Re: Poynton Pool – Proposed Works to the dam

Comments on the outline design of the safety works

Figure 2: Key features of Poynton Pool

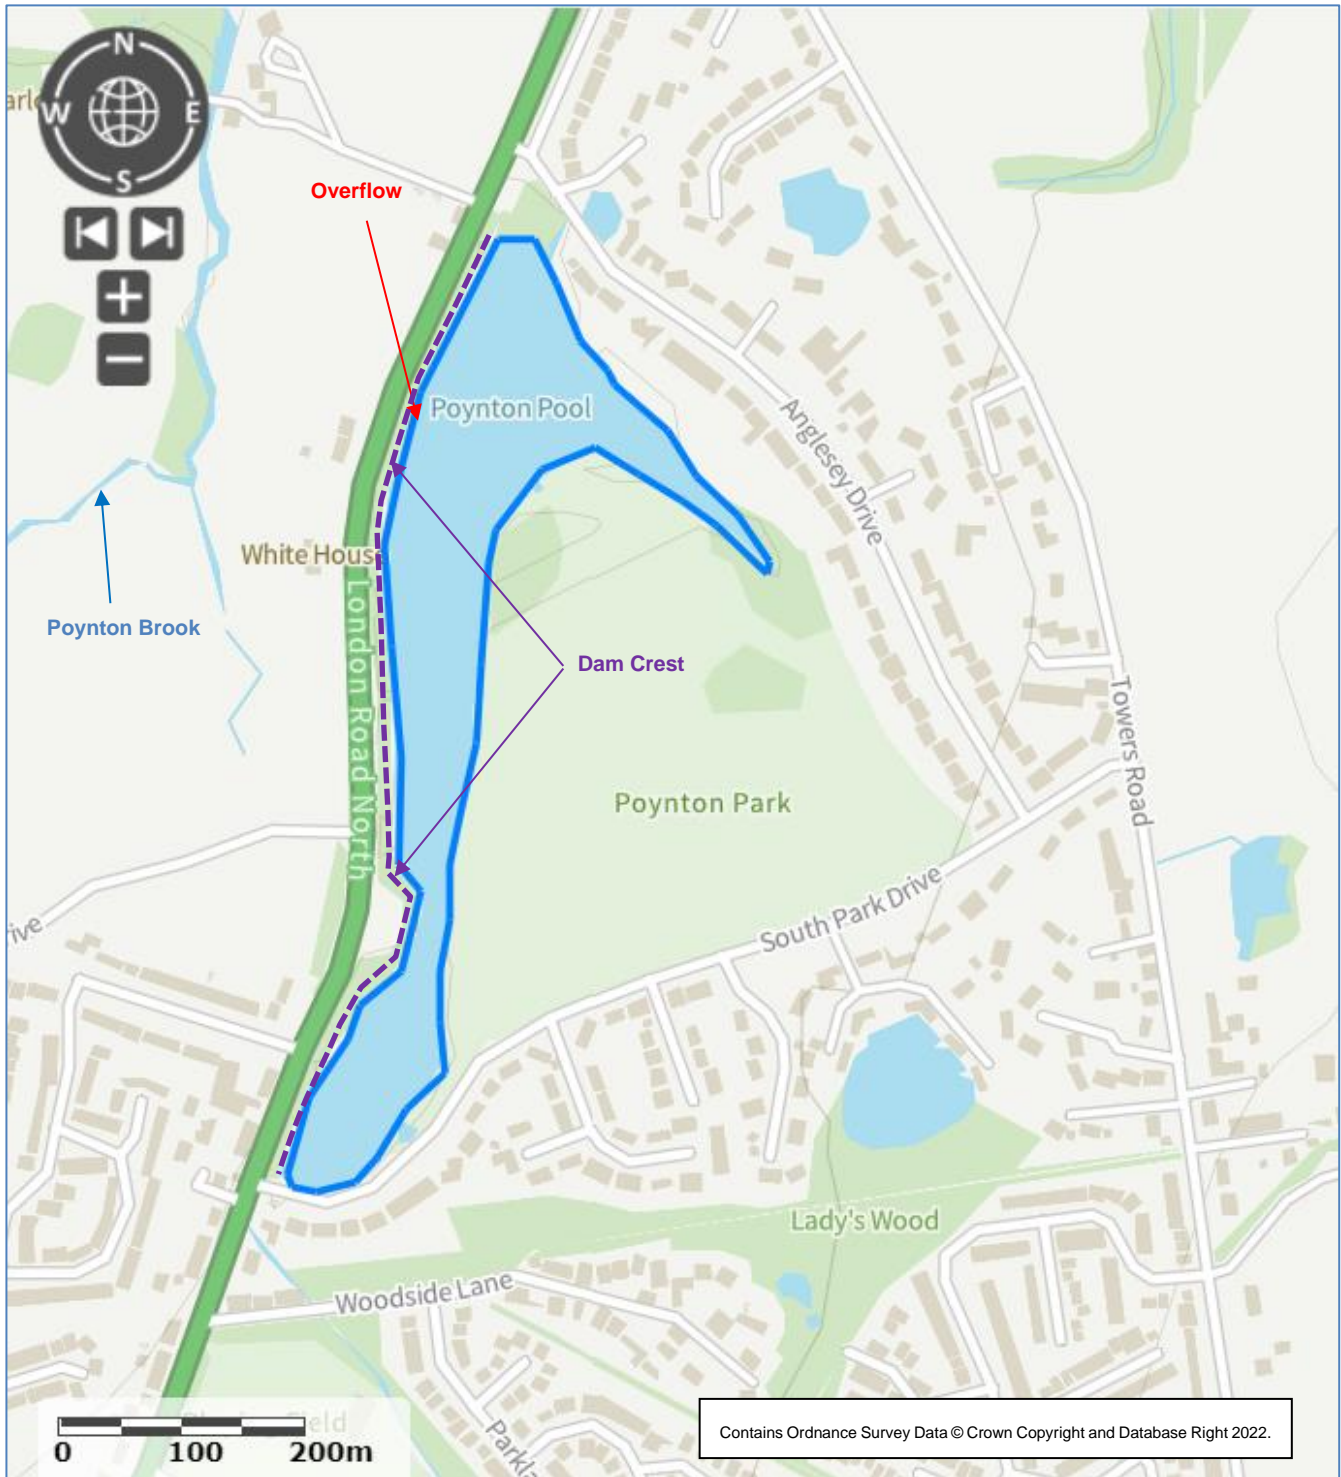
The Pool has been formed by the construction of an earth embankment dam running parallel and to the east of the A523 London Road along a north-south axis for a distance of approximately 800 metres (see Figure 2). The dam varies in width and height but is highest in the location of the overflow (which probably coincides with the original watercourse 'valley').

Water levels in the Pool are controlled by an outlet weir located approximately 145 metres from the northern end of the dam. The inlet weir has a security/debris screen to prevent unauthorised access and to collect larger debris. Flow from the weir cascades into a brick chamber before entering a pipe culvert which carries it through and under the dam and the A523 road to discharge into an open watercourse channel to the west.

Figure 3: Estimated extent of flooding from a breach of the dam at Poynton Pool (source: The Environment Agency)

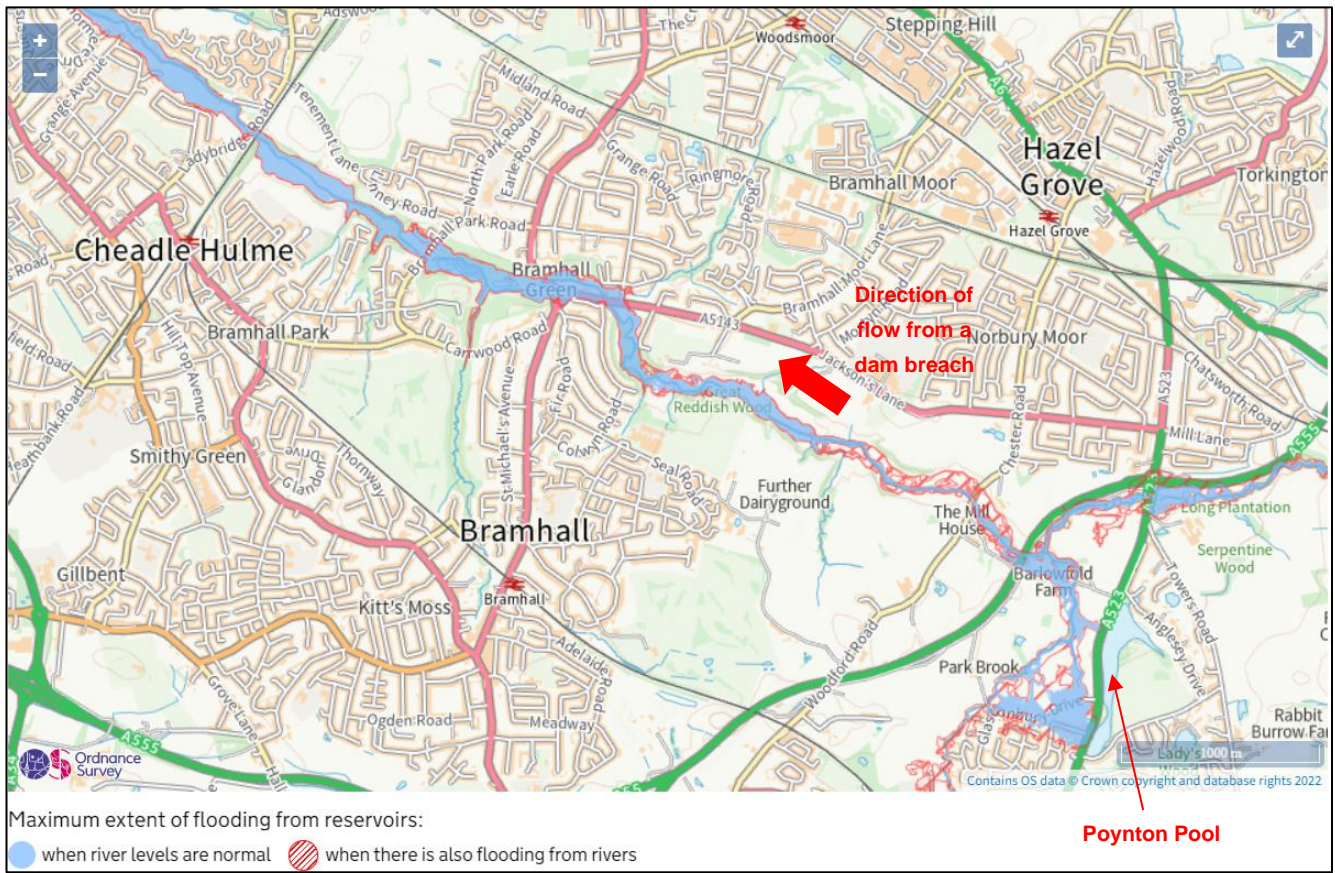
The Pool has been designated as a 'High Risk' reservoir under Section 2A of the RA1975 by the Environment Agency as it is considered that in the event of an uncontrolled release of water from the reservoir, human life could be endangered. This designation will have been based on, amongst other things, the results from a computer simulation of the potential flood depths and velocities to land downstream in the event of a dam breach. An excerpt from the map showing the possible consequence is provided in Figure 3. This shows the A523 road and property in Bramhall Green and Cheadle Hume potentially at risk of flooding. While the modelling will have made some assumptions regarding dam height, location of a breach, etc., given the location of the Pool close to housing, I can see no reason to question the High Risk designation.
